City of Richmond
Planning and Development Department

Report to Development Permit Panel

File: DP 06-325115

Re: **Application by AM-PRI Construction Ltd. for a Development Permit at
9751 Ferndale Road (formerly 9711, 9751 and 9771 Ferndale Road)**

Appendix 1
 Tree Survey & Site Map
 9711, 9751, 9771 Fensdale Road
 Richmond, BC
 PLAN # 3D JAN 10 2007
 DP 06325115

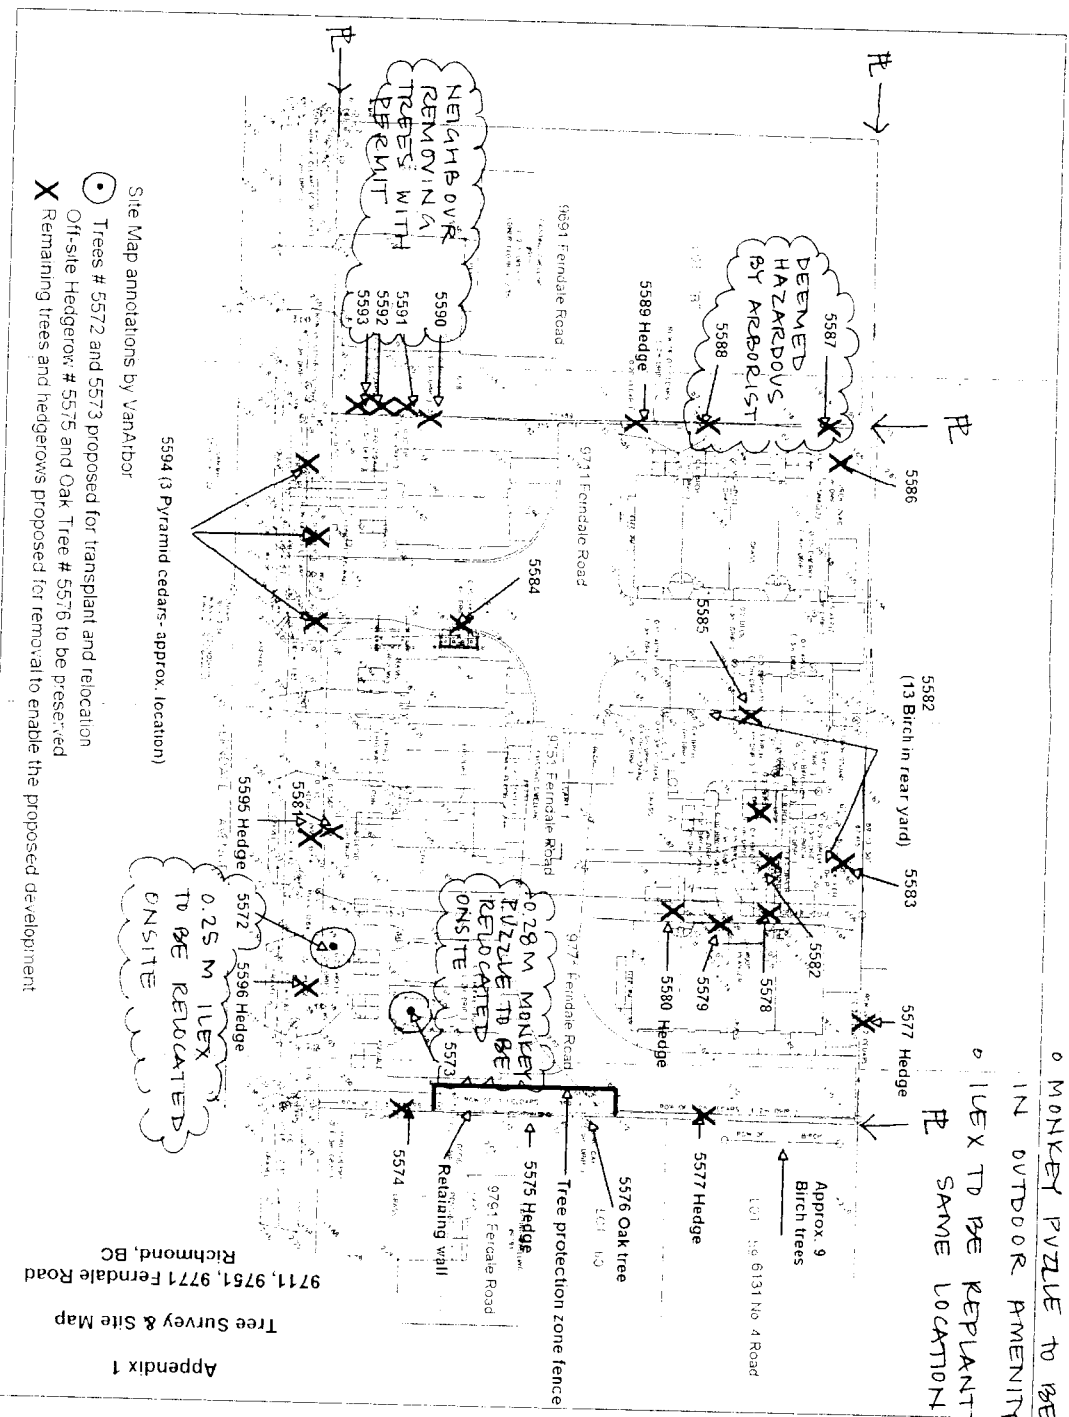
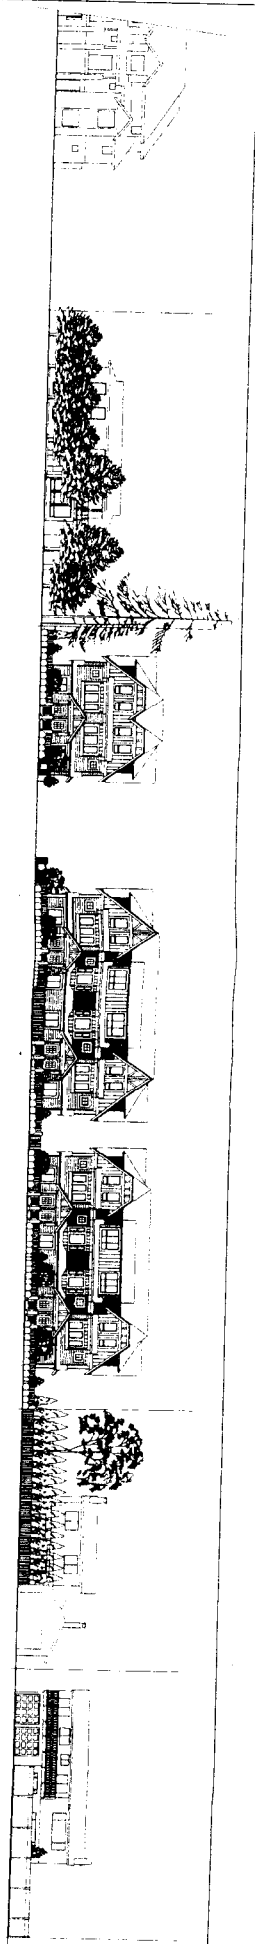
- paving is too close to oak tree #5576 to allow it to be retained;
- bedroom liveability is questionable, interior design is tight and it may be very difficult to get furniture into the bedrooms;

- tree retention requires further consideration – ***A tree-moving company has been contracted to remove, store and re-plant the 2 existing monkey puzzle and Ilex trees onsite. The applicant's arborist has specified the retaining wall design for the retention of the neighbour's Oak tree to the east. In addition, permeable paving will be used both in the accessible visitor parking space and apron;***

○ MONKEY PUZZLE TO BE REPLANTED IN OUTDOOR AMENITY AREA
 ○ ILEX TO BE REPLANTED AT SAME LOCATION GENERALLY

PLAN # 4

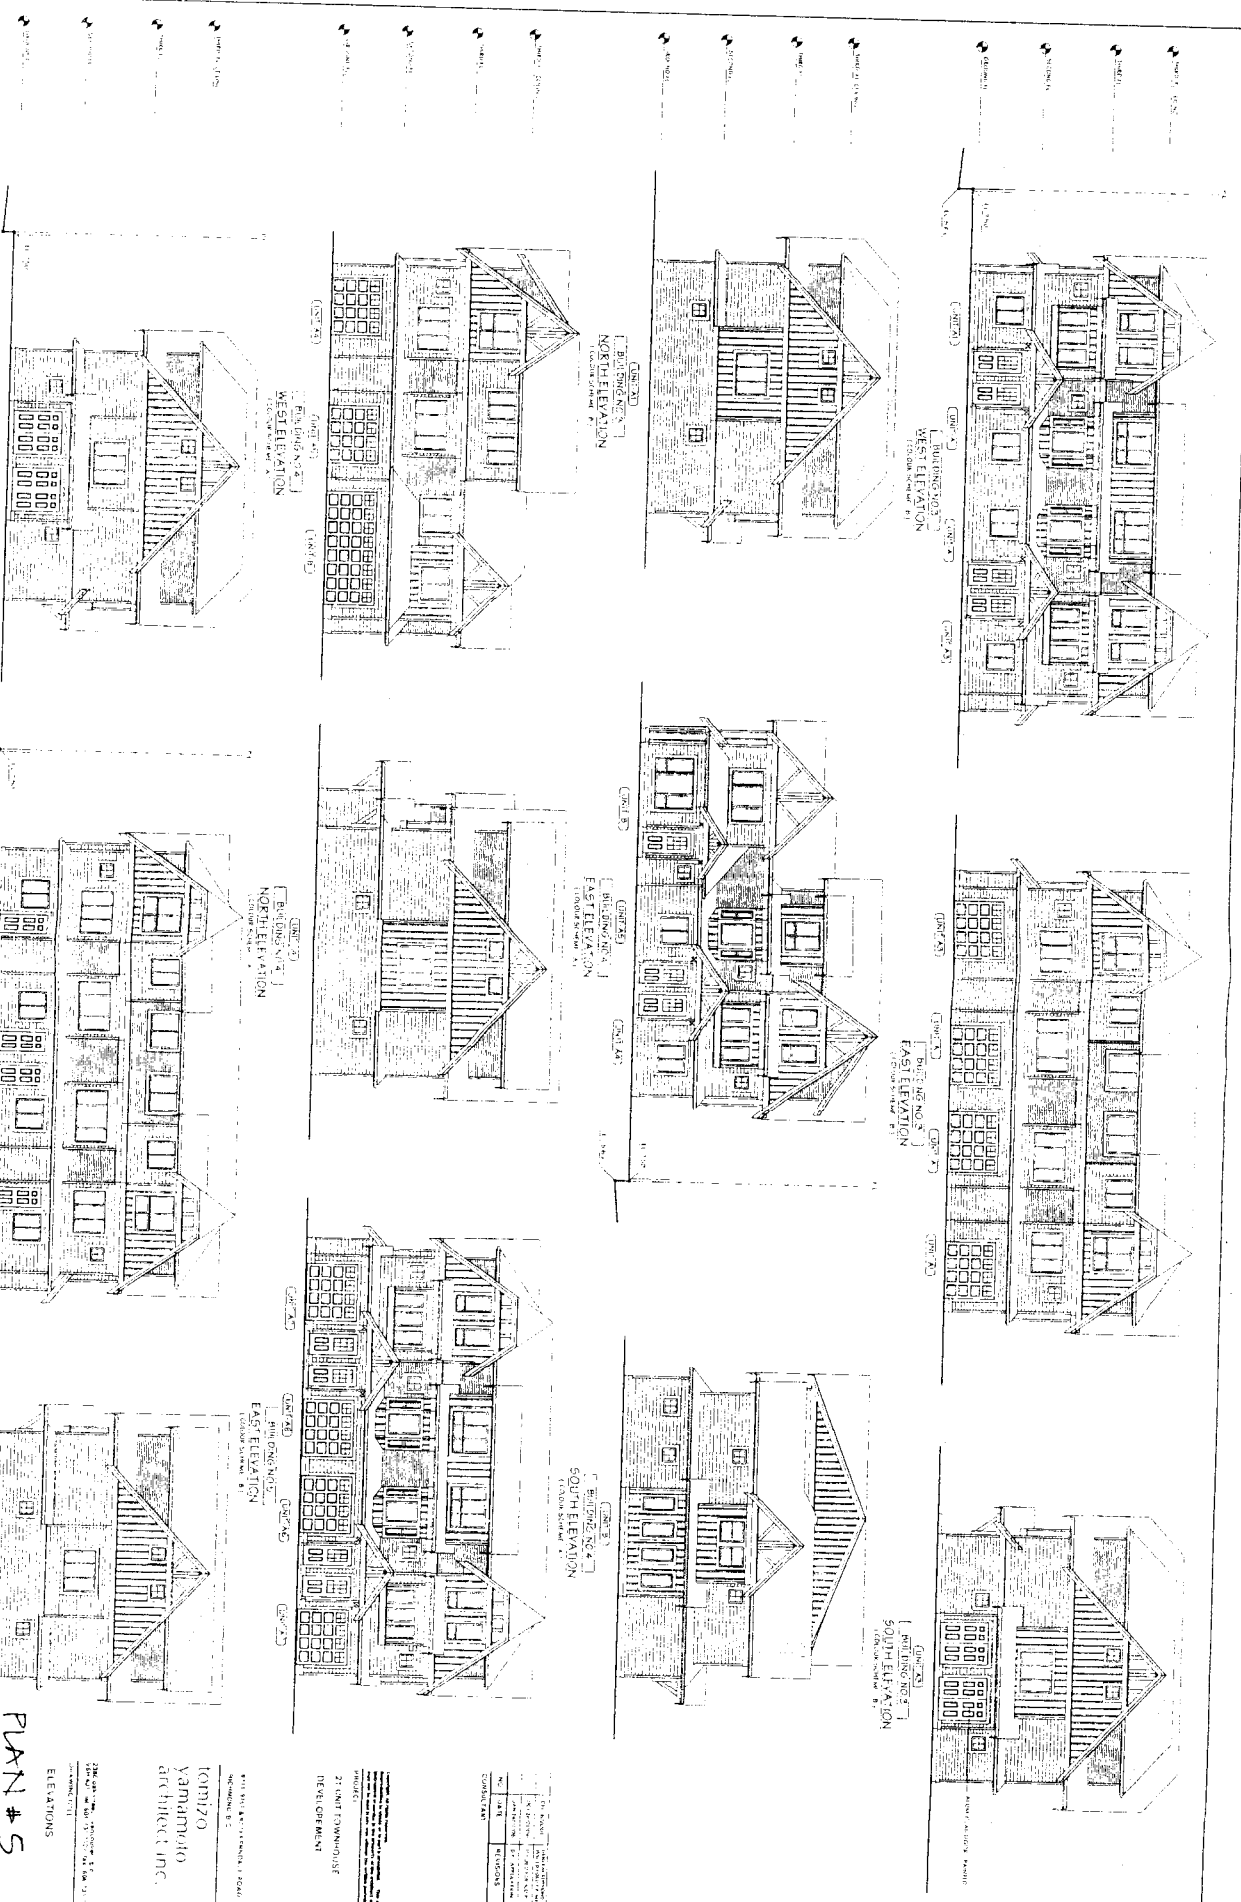
- The Ferndale Road streetscape is animated with pedestrian-oriented front entries (**Plan #4**). A communal pedestrian entry to the development is also provided;
